GAEP West Development Plan Overlay

Position Paper

Client	Victorian Planning Authority
Project	GAEP West Development Plan Overlay
Report title	Position Paper
Version	03
Authors	C.Tsioulos & R.Swan
Project manager	C.Tsioulos
File name	VAP00001_R_PositionPaper_GAEPWestDPO_FINAL_NOV2025.docx
Project number	VPA00001

Figure 1: Proposed MAB major drainage layout

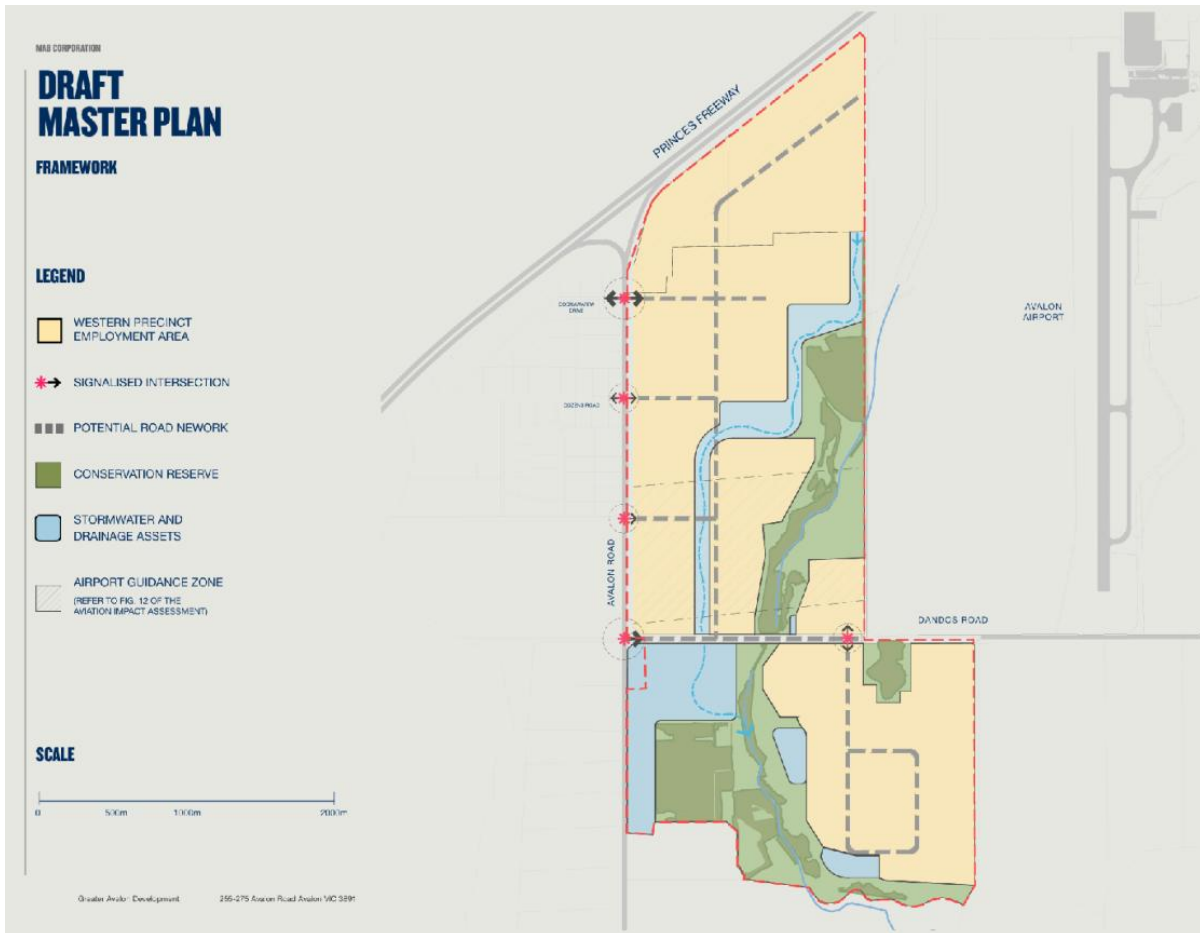
The indicative drainage layout proposed by MAB in Figure 1 below is considered to generally meet the needs of the precinct. The proposed layout includes:

- A conservation reserve is proposed to convey the external flows through the site via existing watercourse that extends through the site. The watercourse has been identified has have environmental values, particularly south of Dandos Road.

- A 100m wide linear reserve to convey the internal flows generated from the site. It is possible that the allocated 100m wide corridor or reserve is oversized from a hydrological perspective. The area required should be determined through modelling as a part of the drainage strategy development, noting that areas within the corridor may be required for environmental or conservation purposes

- A number of water quality treatment wetlands, proposed within or adjacent to the linear reserve to treat the internally generated stormwater runoff to greater best practice standards.

- A large retarding basin or basin or stormwater management area south of Dandos Road and immediately east of Avalon Road.

HARC believes that this proposed layout generally would meet the needs for the conveyance of major and minor flows through the site. However, we are of the opinion that the proposed lake/open water body south of Dandos Road, adjacent to Avalon Road is unnecessary from a stormwater quantity management perspective and has the potential to attract wildlife, whereby creating a potential risk for aircraft safety at Avalon Airport.

Figure 4: Catchment A and Catchment B potential outfall locations

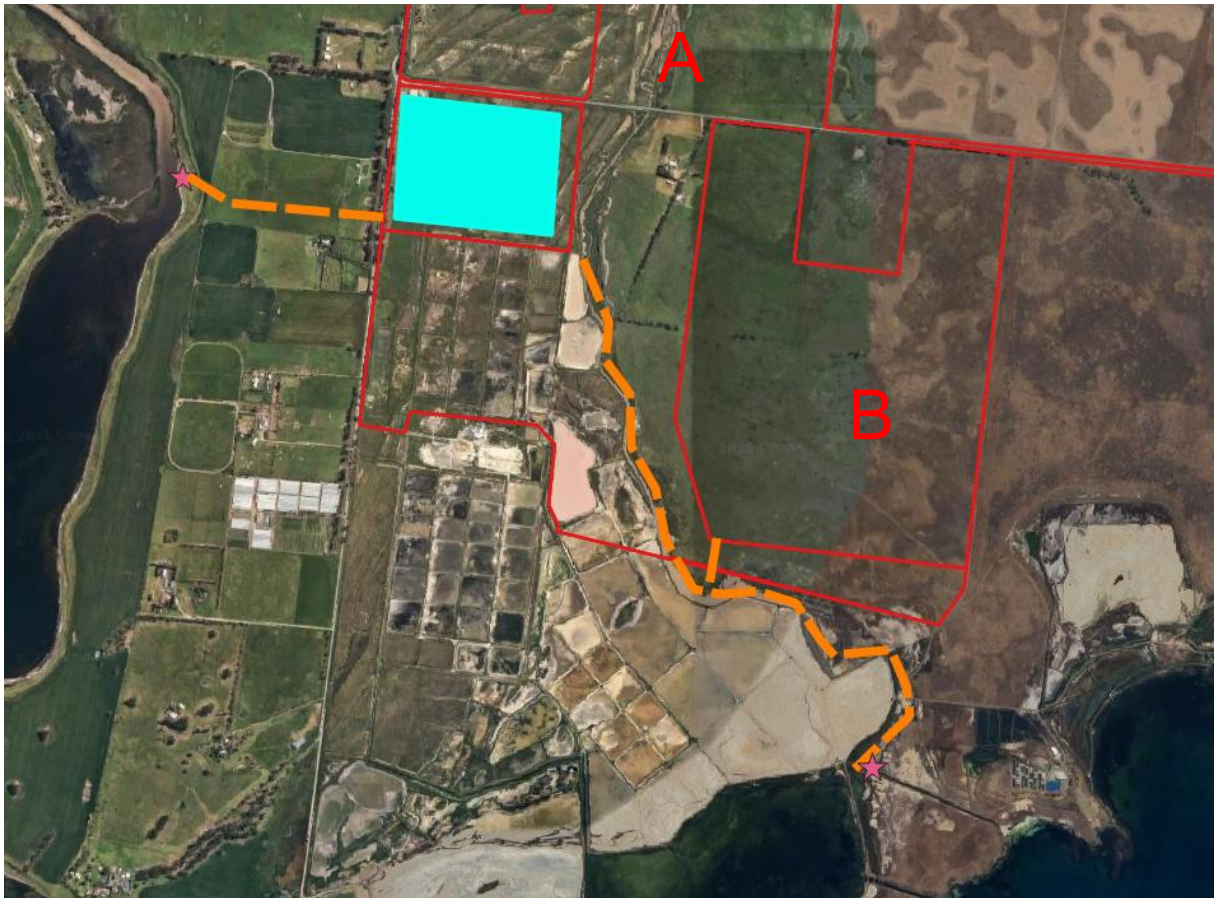
The current upstream catchment is around 1200 hectares of which more than 50% is north of the Princes Freeway and considered to be uncontrolled and untreated. The 630 hectares of catchment with the GAEP West site can be treated for stormwater quality and volume to pre-development conditions. Whilst there has been flood modelling for the upstream catchment, it is the low flows and environmental flows that are little understood, as well as what those existing flows mean for the ACR. HARC consider there to be two possible outfall scenarios or combination of the two as shown in Figure 4

- 1) Outfall the entire site through the Avalon Coastal Reserve following stormwater quality treatment and volumetric flow control.
- 2) Outfall some or all flows from Catchment A to the turbid estuarine environment of Hovells Creek where there is unlikely to be any seagrass due to lack of light. And outfall the quality and volumetrically treated flows from Catchment B to the existing waterway.

Figure 5: Proposed water quality treatment locations - LIVV

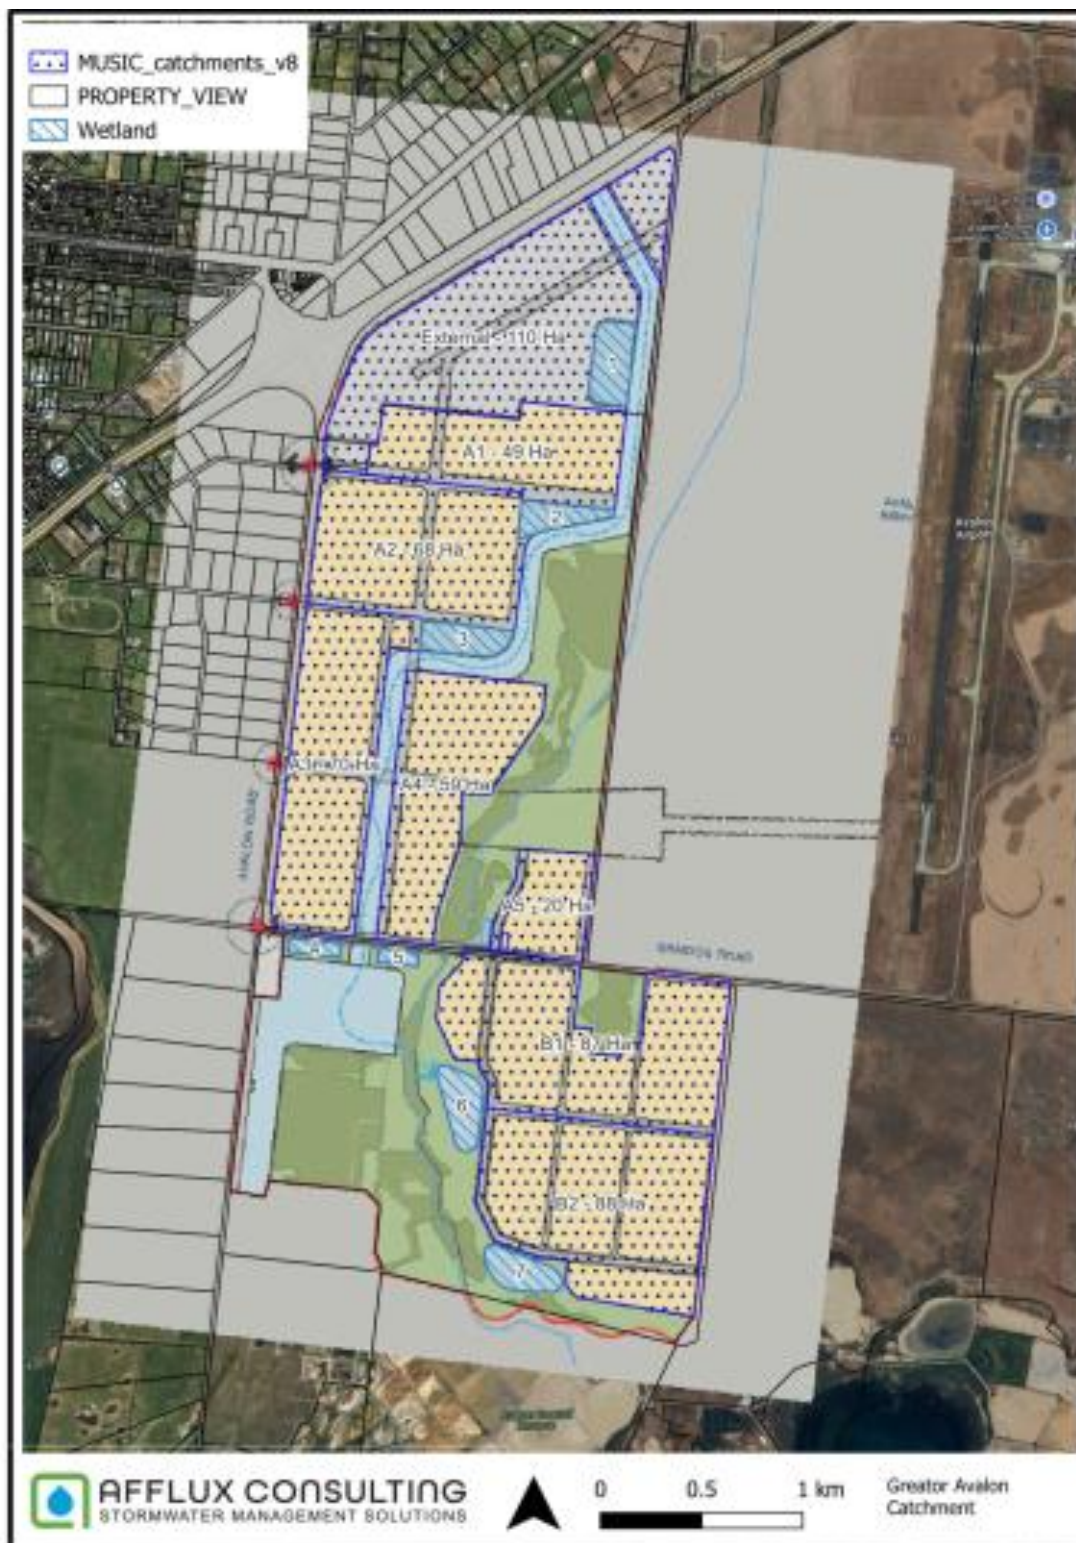
The current LIVV strategy proposes two wetlands for water quality treatment purposes.

The MAB drainage strategy proposes six (6) water quality treatment wetlands and works off the assumption that LIVV are planning a single wetland at the boundary between the sites to the east. The MUSIC modelling undertaken for the planning stages of the Avalon PSP (now the DPO process) by Afflux has modelled treatment to achieve better than better than Best Practice targets. The better than Best Practice targets align with targets for Western Port Bay. Western Port Bay is also a home to seagrass beds and classified as a Ramsar wetland. It is worth noting that the catchments of Western Port Bay contain significant tracts of agricultural land. Seagrass covers intertidal and subtidal areas of the Western Port Ramsar Site and has been highly variable over time.⁴ This location is also different in depths, wind and wave exposure and coverage.
